CERTIFICATE OF APPROPRIATENESS STAFF REPORT

CERTIFICATE OF APPROPRIATENESS CASE #: PCOM-000093-2021

APPLICANT NAME: Tractor Supply Co.

ACTION REQUESTED: The owner is requesting approval of a Certificate of Appropriateness application in order to allow construction of a greenhouse addition to an existing shopping center building.

1 FRONT EXTERIOR ELEVATION
1/8" = 10'

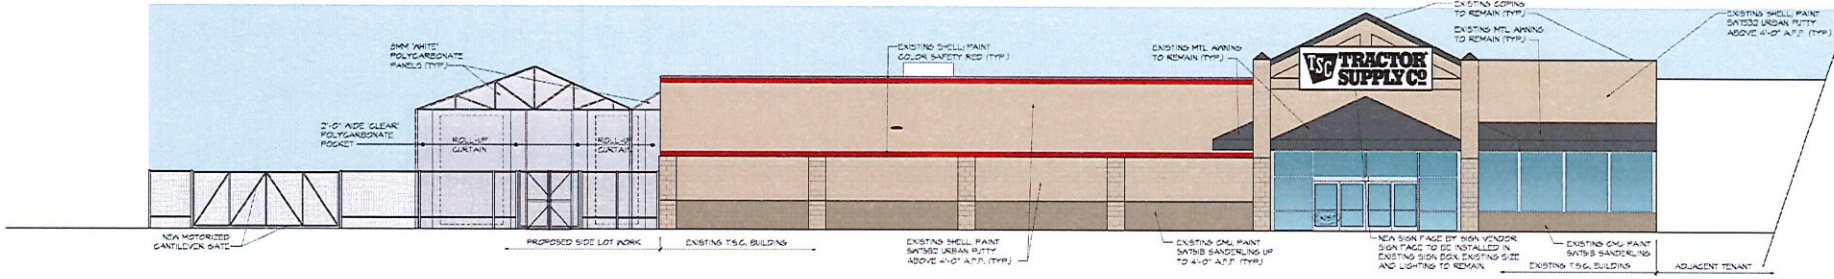
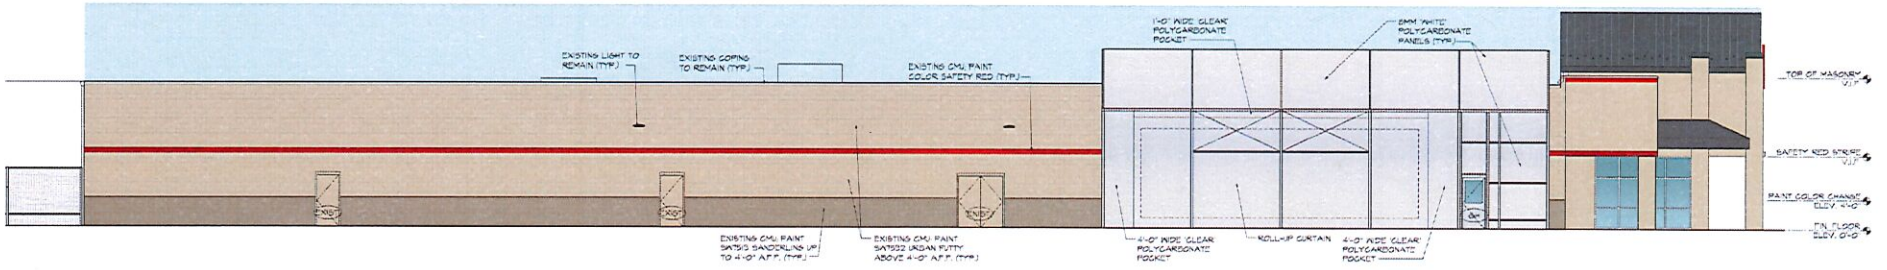
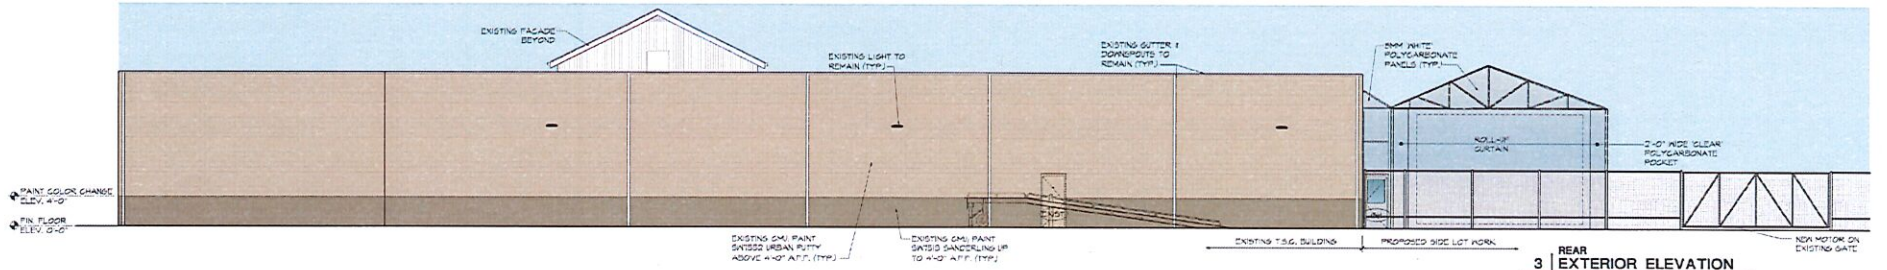
This proposed greenhouse addition will have translucent polycarbonate paneling and roofing. The addition will be constructed in line with the façade line of the existing retail space for Tractor Supply. The addition will be one-story in height. The proportion of the addition will only constitute a fraction of the overall proportion of the existing retail unit size for Tractor Supply.

Overall Elevation with Proposed Sign

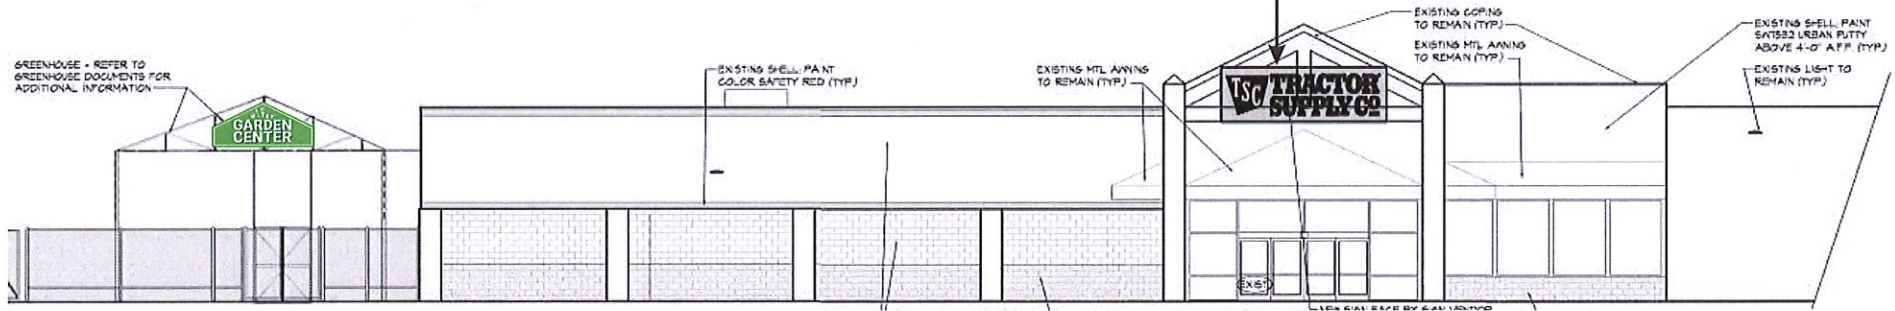
A sign is proposed to be placed on the greenhouse addition. The proposed sign does appear to meet the general criteria for the Corridor Design standards, however, the sign may exceed the number of wall signs permitted under Article XII of the Zoning Ordinance. This issue would need to be determined at the time of permitting.
